Groundwater Application Review Summary Form

Application # G- 19440

GW Reviewer Gabriela Ferreira Date Review Completed: October 11, 2024

PUBLIC INTEREST REVIEW FOR GROUNDWATER APPLICATIONS

Well Location Map

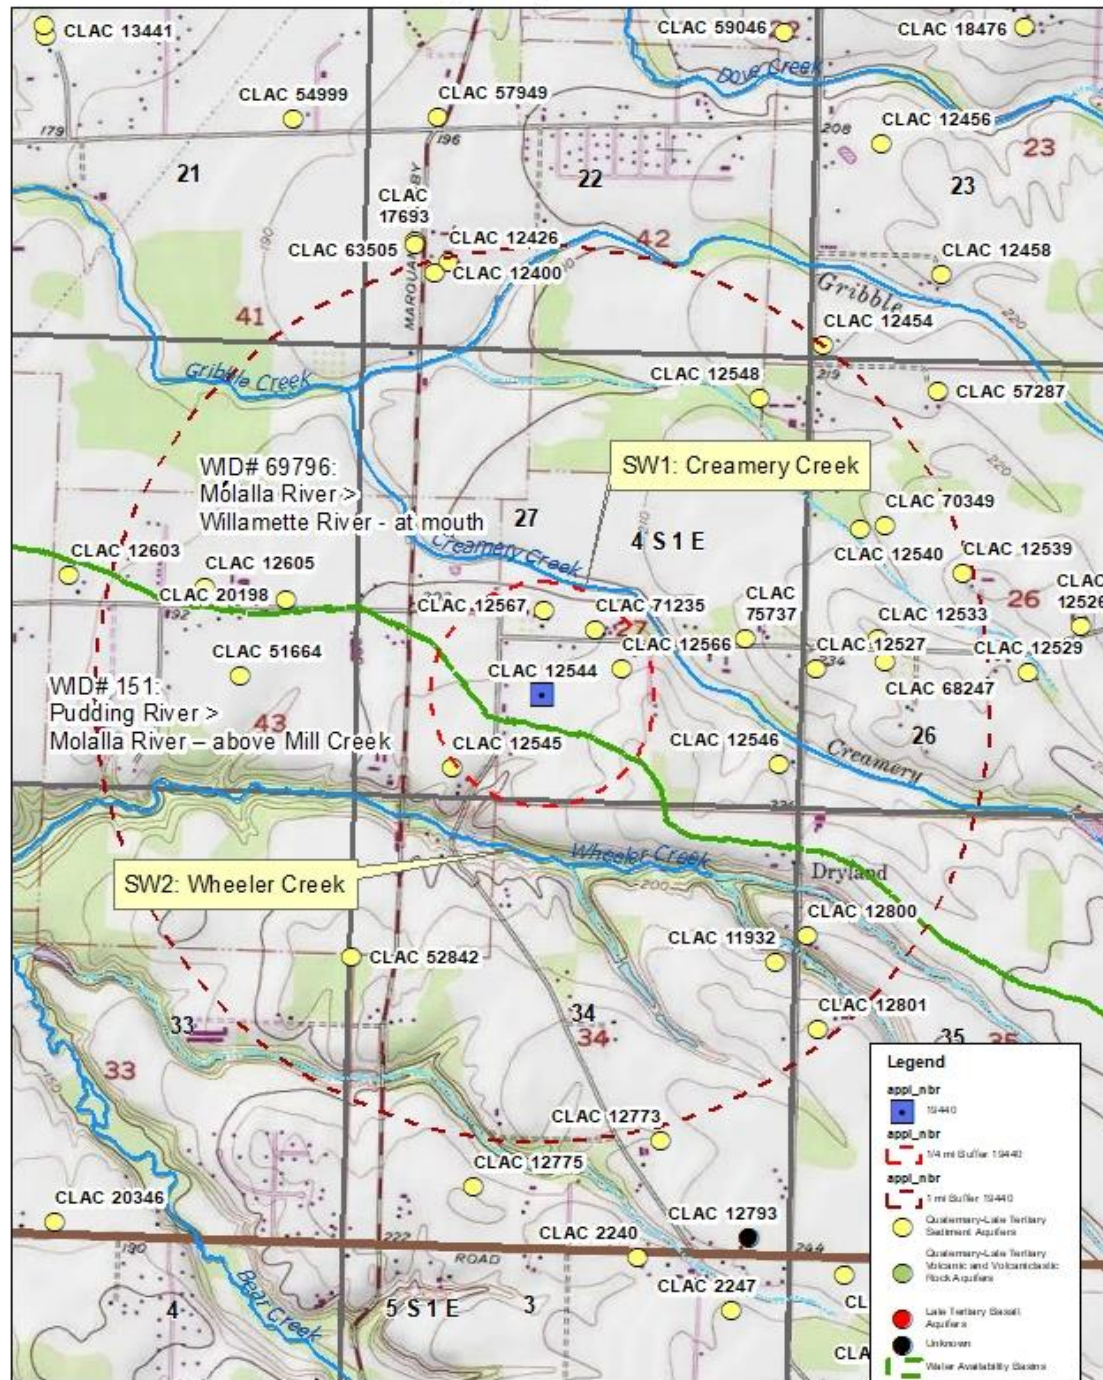
Note: The location of Well 1 / CLAC 12544 as described by metes and bounds within the application maps to a location approximately 100 feet north of the location shown on the application map; this discrepancy produces a location error of at least 100 feet, such that the exact distance from Well 1 to the nearest stream reach is not known. If the applicant provides additional well location details such that the well is found to be located within ¼ mile of the hydraulically connected surface water bodies, the findings described within Section C should be revised accordingly.

Water-Level Measurements in Nearby Wells

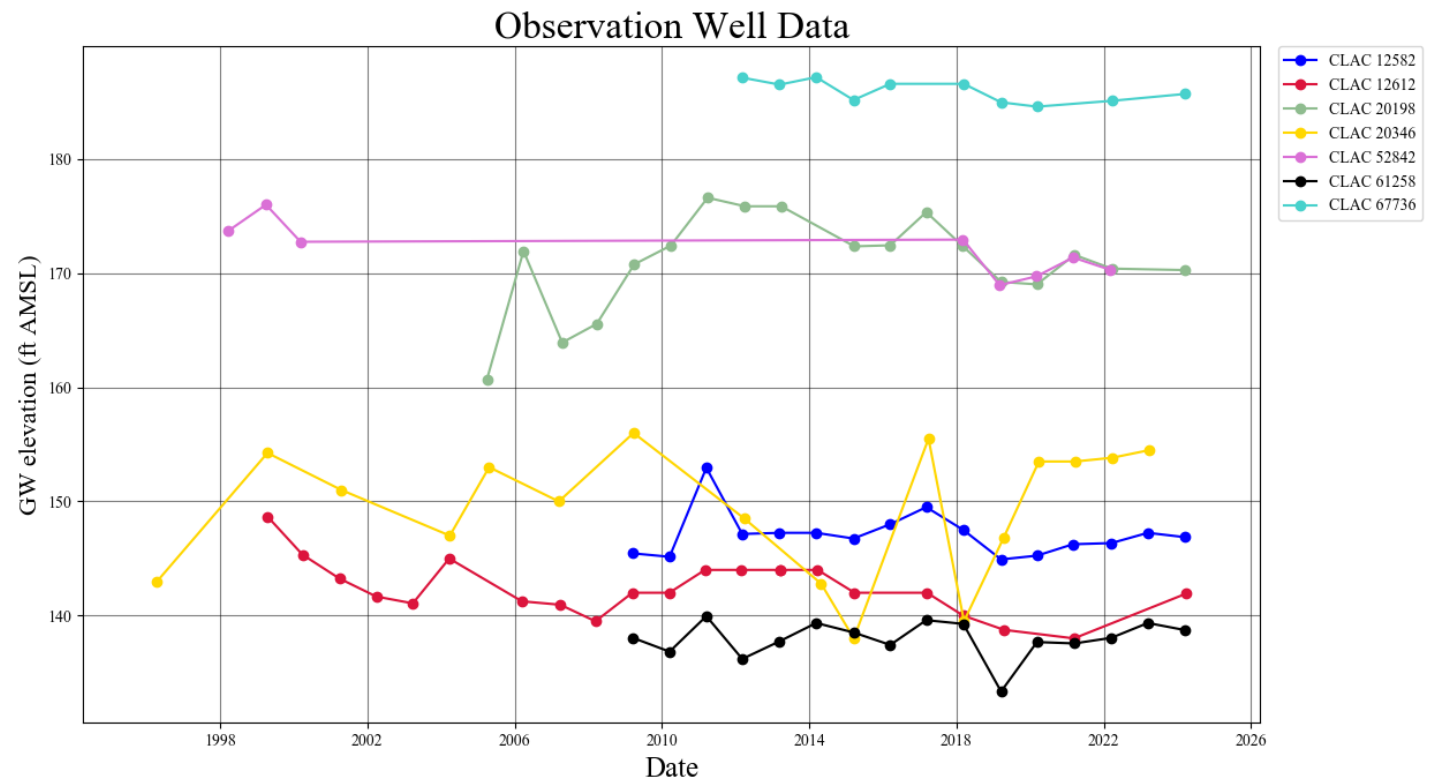
Seven wells with sufficient water level data for evaluation were identified within approximately 1.5 miles of the POA, ranging in total depth from 150 to 378 feet bls and reported water level elevations from about 135 feet above mean sea level (amsl) to 188 feet amsl. Water level data for these wells are generally stable over the time period available (~mid-1990's through present) although some variability up to ~15 feet is observed.

The stable groundwater conditions indicate that the proposed use is within the capacity of the resource. However, in order to monitor and protect the resource and other groundwater rights in the area, the recommended permit conditions should be included.

Theis Interference Analysis

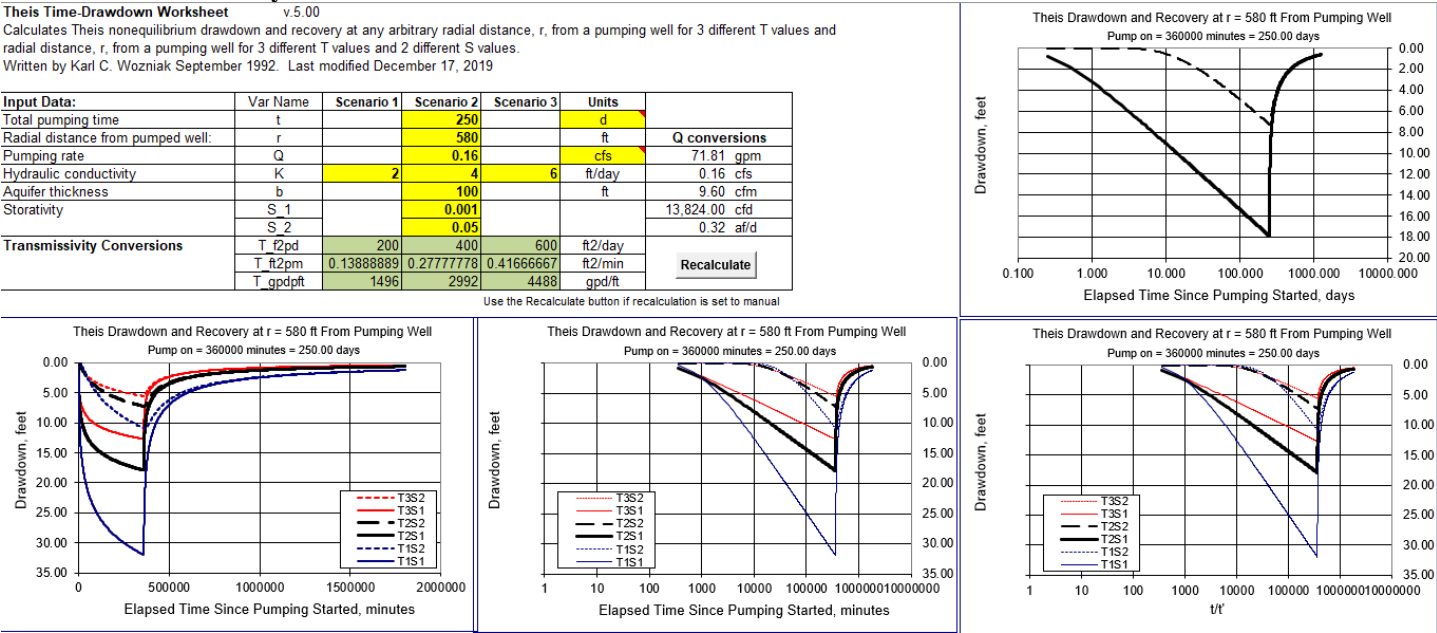
The nearest groundwater user was identified as CLAC 12566, located approximately 580 feet northwest of the proposed POAs. CLAC 12566 is a permitted irrigation well completed to a depth of 154 feet bls and sealed to 36 feet bls and a reported water level of 32 feet bls at time of drilling (1973). Despite not fully penetrating the alluvial aquifer system, potential impacts on CLAC 12566 were modeled using the attached Theis drawdown analysis and assuming the full duty and rate of the proposed POA. Transmissivity values are based on pump tests from nearby alluvial wells. Under the most conservative parameters modeled, drawdown may temporarily exceed 30 feet bls. It appears unlikely that interference in

excess of the typical permit condition limits (Condition 7c) would occur at CLAC 12566 as a result of the requested withdrawal.
